# MARION TOWNSHIP PLANNING COMMISSION AGENDA

# 1) REVIEW PUD#01-20 TAMARACK PLACE (SUNRIDGE III) PRELIMINARY SITE PLAN REVIEW

Re: <u>Tamarack Place (Final Phase of Sunridge PUD) – revised Preliminary Site Plan</u> submittal

## PUD Site Plan Review For Marion Township, Michigan

G-1<sub>.0</sub>

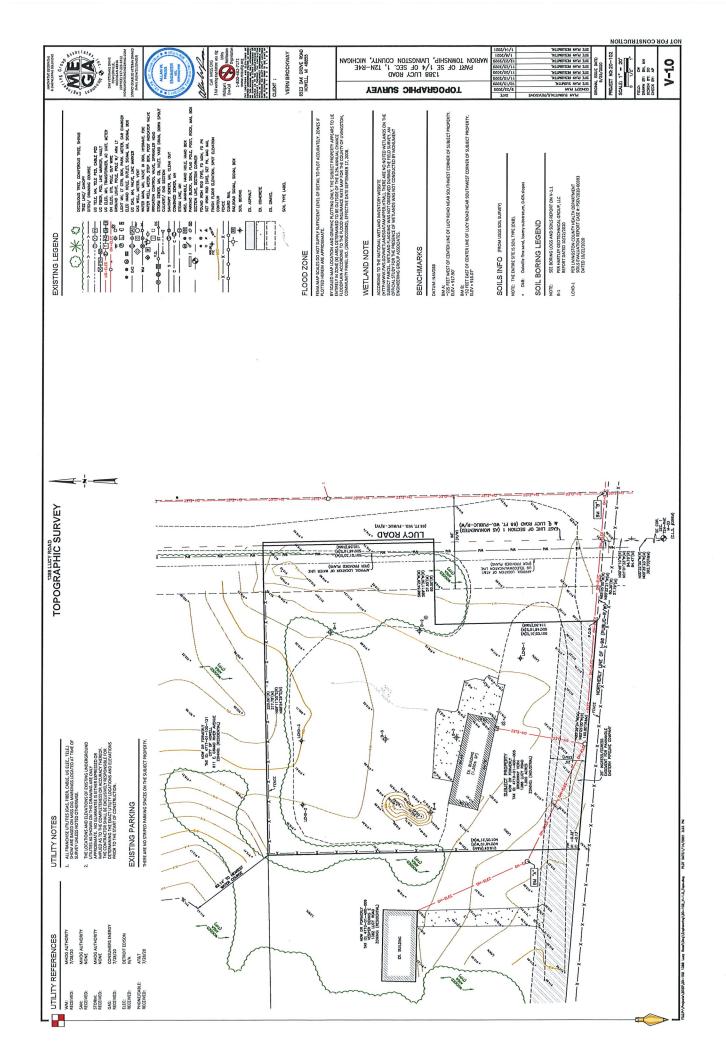
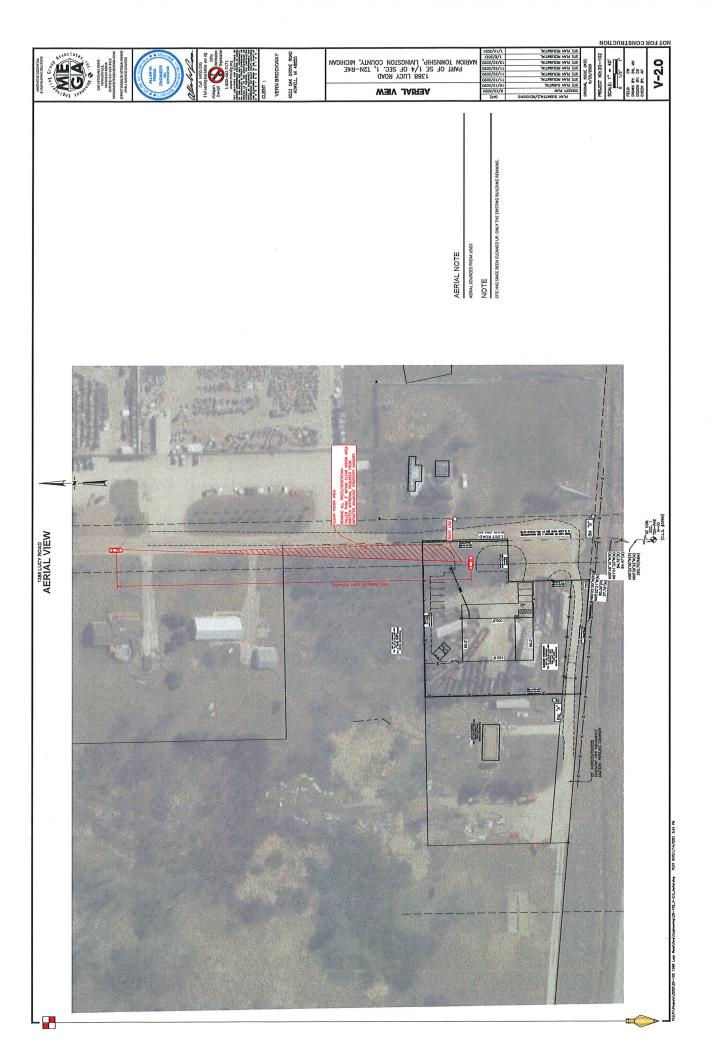
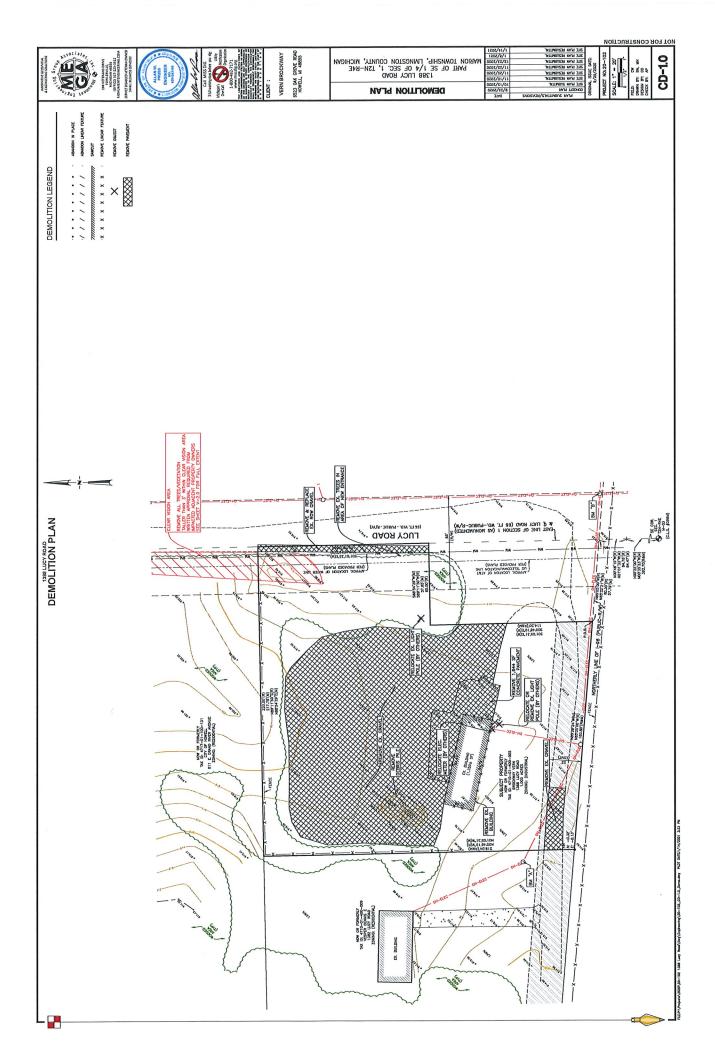
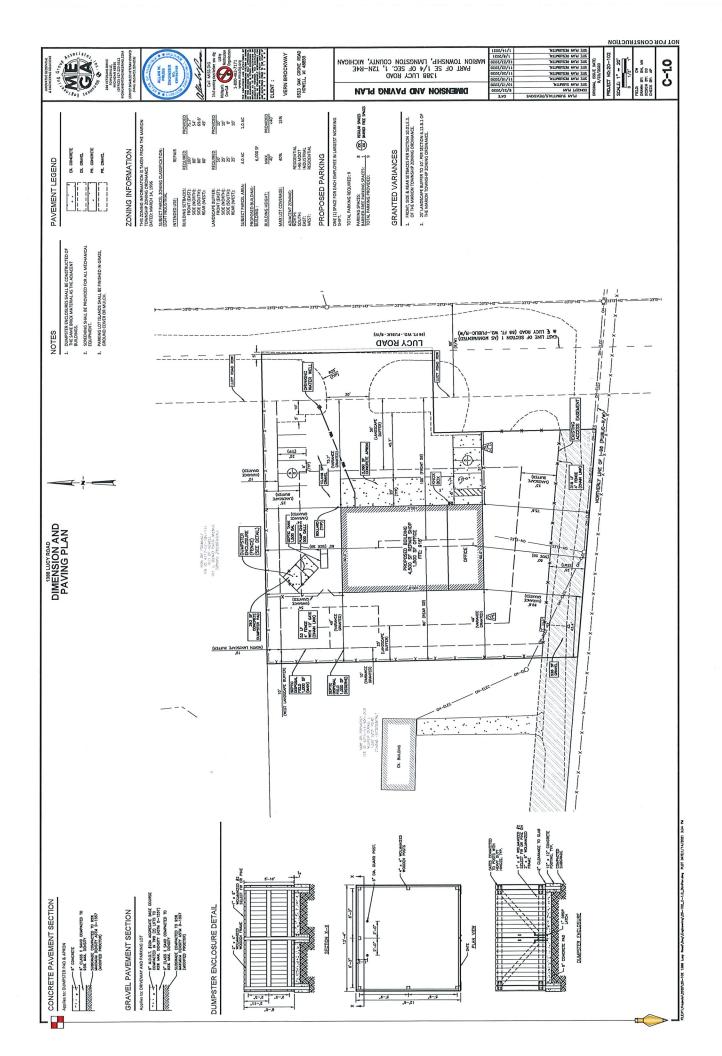
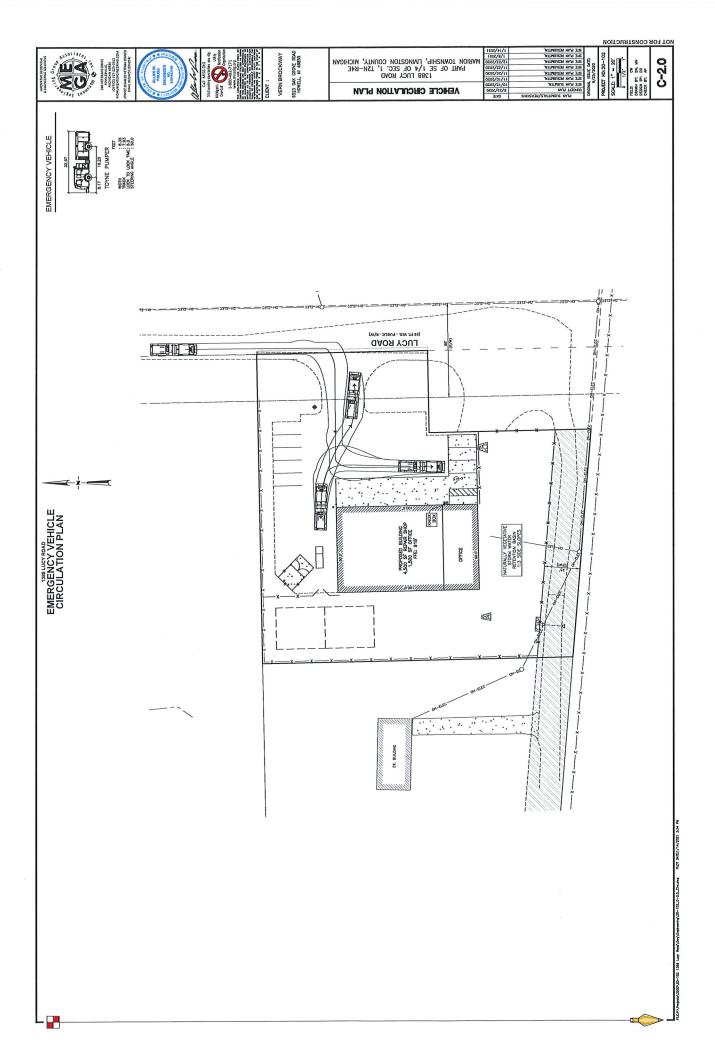
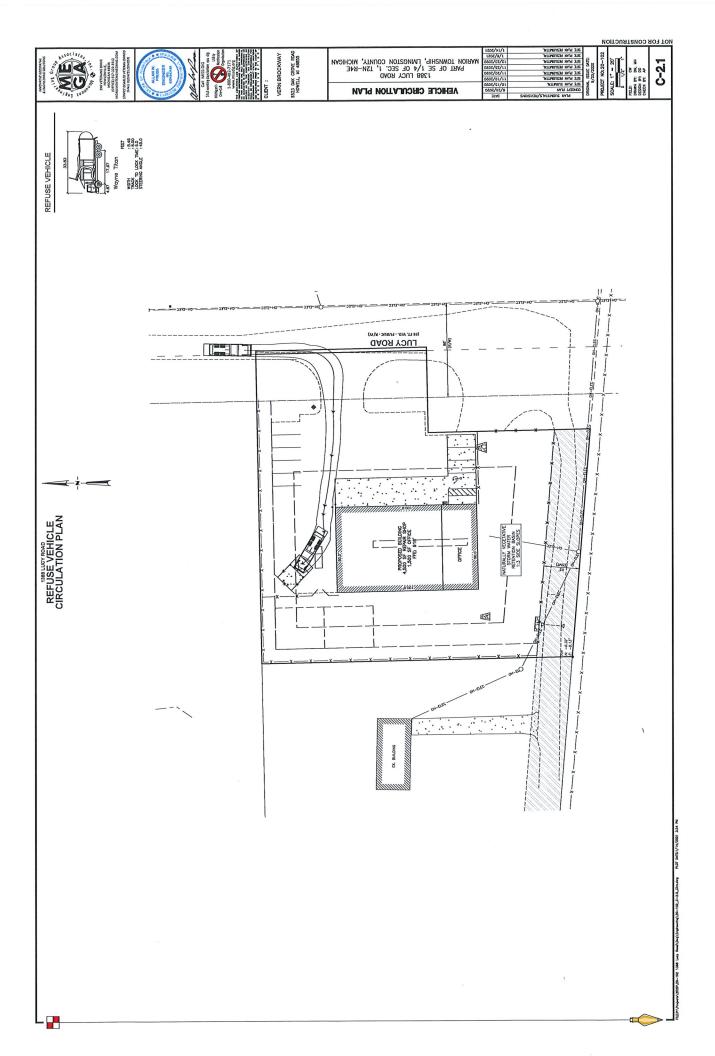
Spicer is recommending withholding of approvals from other agencies and consultants 1. Plans should be reviewed and approved by:

- 1 Storm water calculation can be found one sheet C-9.2.
- 2 The west side of the site is graded to flow south into the retention basin overland as the elevations allow for this. There are no proposed ditches on site.
- 3 The silt fence is called out to be 36".
- The swale into the retention basin now has rip rap shown to the bottom of the basin to minimize potential erosion in this area.
- 5 Silt fence details are on the plans.
- 6 There are no ditches on the plans.
- 7 The outlet has been redirected to not be over the existing driveway.

Plans have been resubmitted with one comment concerning the orientation of the emergency spillway from the retention basin. MEGA is waiting on further direction from LCDC.

- 1. Well has been moved to provide min 75' separation from the retention basin
- 2. Septic tank has been moved to provide min 50' separation from retention basin
- 3. We understand other applications will be necessary prior to starting construction.

a. Fire Marshal MEGA Assumes Twp. has submitted plans

c. Livingston County Drain Commissioner Plans submitted for erosion control. Spicer to

d. Livingston County Road Commission Plans submitted, summary below

e. Livingston County Health Department Plans submitted, summary below

MEGA believes the planners comments have all been addressed during the initial review period.

MEGA has not received review comments from the fire department. MEGA assumes plans have been submitted to the FD by the Township for review. MEGA will address any review comments once received.

UTILITY CALCULATIONS

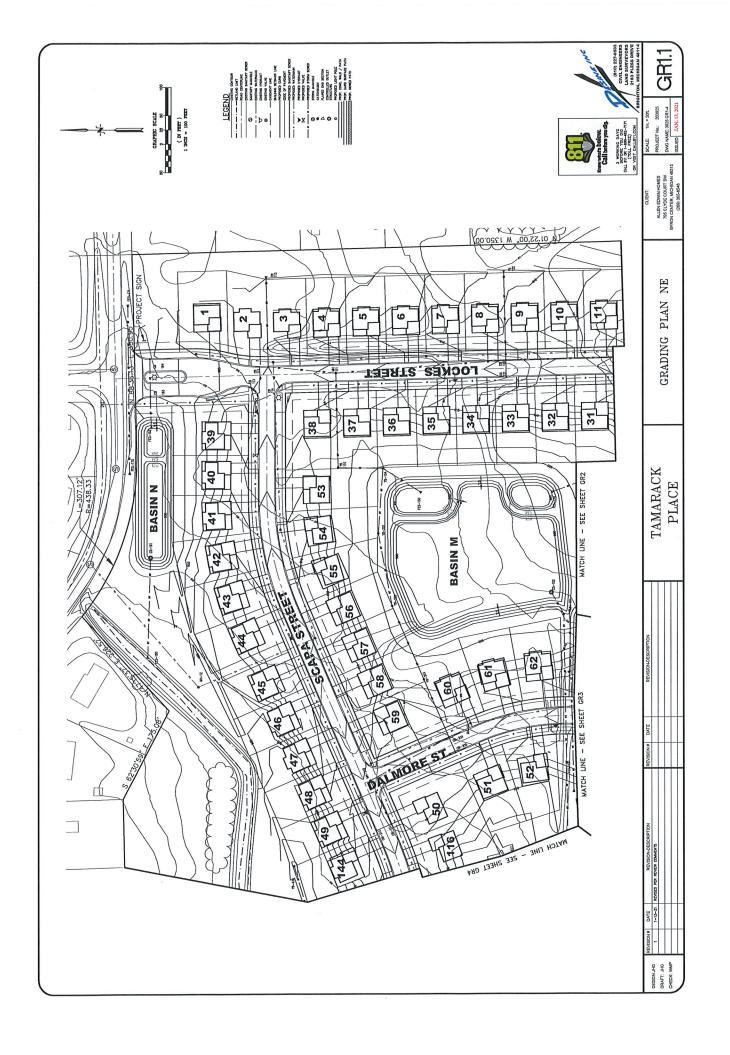
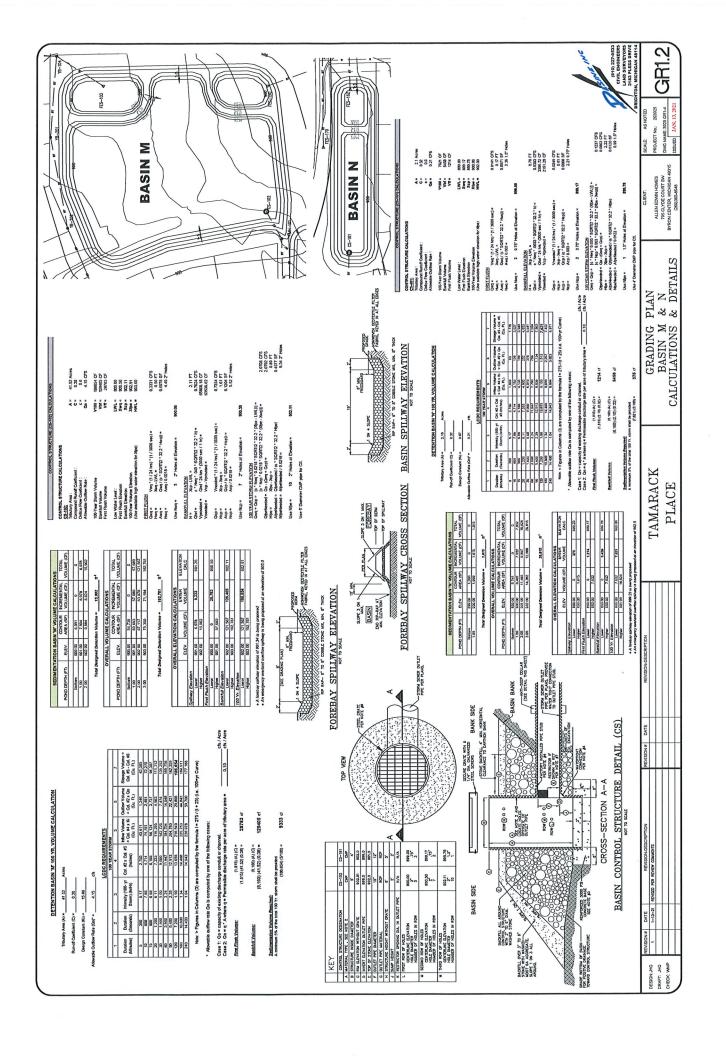
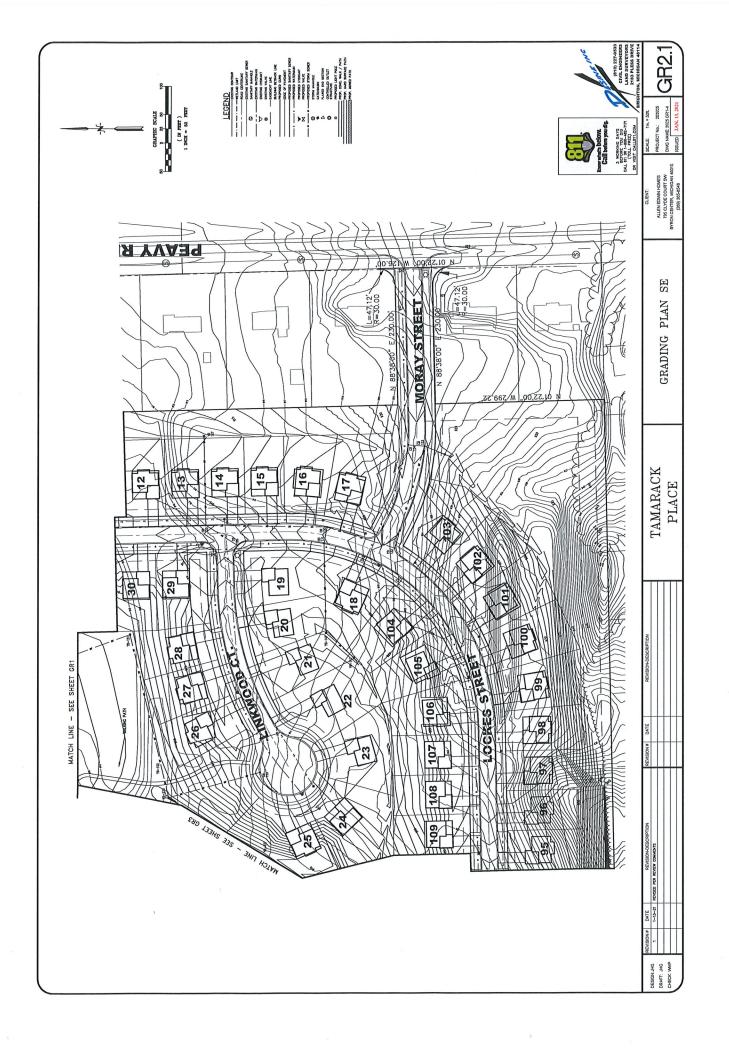
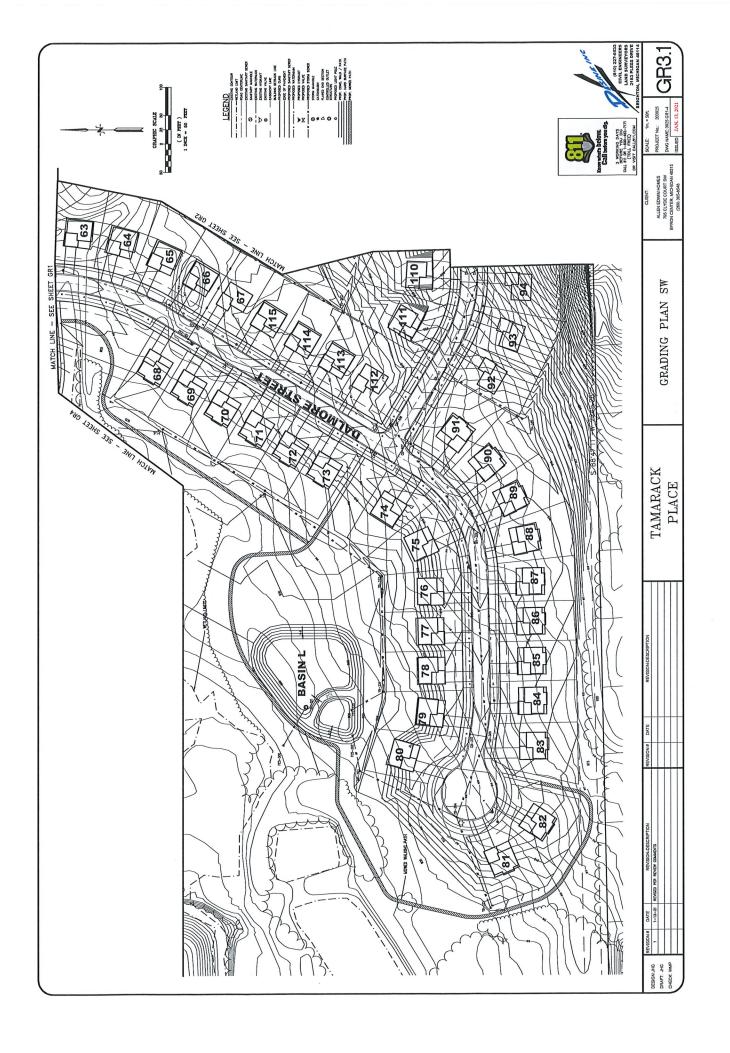
The Preliminary Site Plan has been revised based on written comments received from Carlisle/Wortman Associates, Inc (November 16, 2020), Spicer Group (December 15, 2020) and verbal comments received during the December 22, 2020 Planning Commission meeting. A summary of changes made is attached with this cover letter.

DATE REVISION-DE: 1-13-21 REVISED PER REVIEW COMMENTS
